UNITED STATES  
**NUCLEAR REGULATORY COMMISSION**  
WASHINGTON, D.C. 20555-0001

**SAFETY EVALUATION REPORT**

Docket No. 72-1026  
FuelSolutions™ Storage System  
Certificate of Compliance No. 1026

**Figure 4-4: COBRA-SFS Predictions of FuelSolutions W21 Storage System Radial Temperatures using BFS Level of Enhanced Heat Transfer Between Spacers**

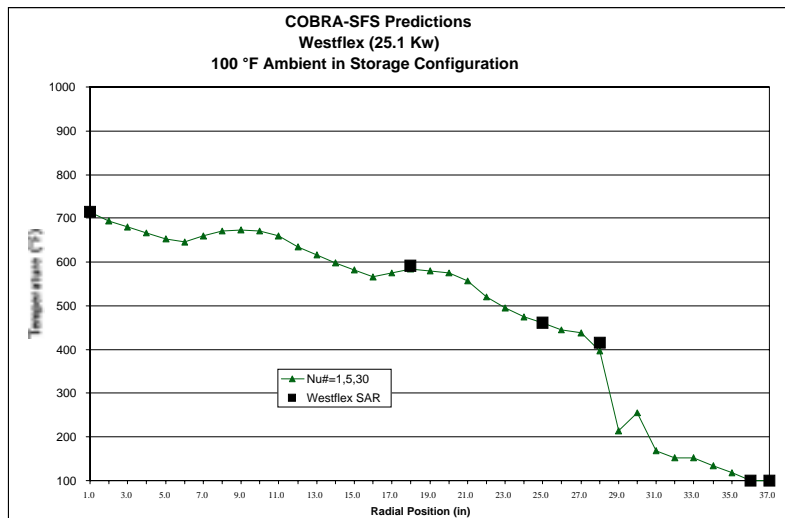
The COBRA-SFS model for the W21 canister was developed from the information presented in the SAR. Two base simulations (i.e., Cases 2 and 3) were performed. First a COBRA-SFS model was developed to treat the radial heat transfer in the regions between the horizontal spacer plates using a similar Nusselt number approach as applied by The applicant. This validated the staff's input model for COBRA-SFS code as providing similar results compared to the applicant's analyses. Next, although data exists for a range of spent fuel storage systems, there is no comparable full scale cask thermal performance data with multiple horizontal spacers, as designed into FuelSolutions. However, data for enhanced heat transfer due to natural convection between plates was identified by The applicant (e.g., Figures 4.4-4 and 4.7-5 in the WSNF-201 SAR). As an independent confirmatory calculation of the physics that exists in the FuelSolutions design, the staff requested PNNL to confirm, through detailed analyses, the thermal characteristics or response of the helium heat transfer mechanisms (e.g., flow and heat transfer rates) that occurs between the spacers.

The first base simulation (Case 2) COBRA-SFS model using the enhanced Nusselt number correlation in between the spacer regions duplicated the applicant's predictions extremely well. The results are presented in Figure 4-4. The radial temperatures are provided at the peak axial temperature level of the spent fuel cladding in the center assembly for all of the components, with the exception of the annulus temperatures, which represent the peak temperature of the flow field which occurs at the inner and outer annulus outlets. For simplicity, only a few points from the FuelSolutions SAR have been provided. Results from the second base simulation (Case 3) COBRA-SFS model are included and presented in Figure 4-5. The radial heat transfer coefficient of the gas between the spacers was treated with a Nusselt number of 3.66, with the exception of the single region that was nodalized in greater detail. It is projected that the peak temperature predicted by the COBRA-SFS model would approach the 715 °F predicted by the BFS model if the flow among all of the spacers was treated in a similarly detailed fashion. The staff, therefore, finds the thermal models used by the applicant acceptable.
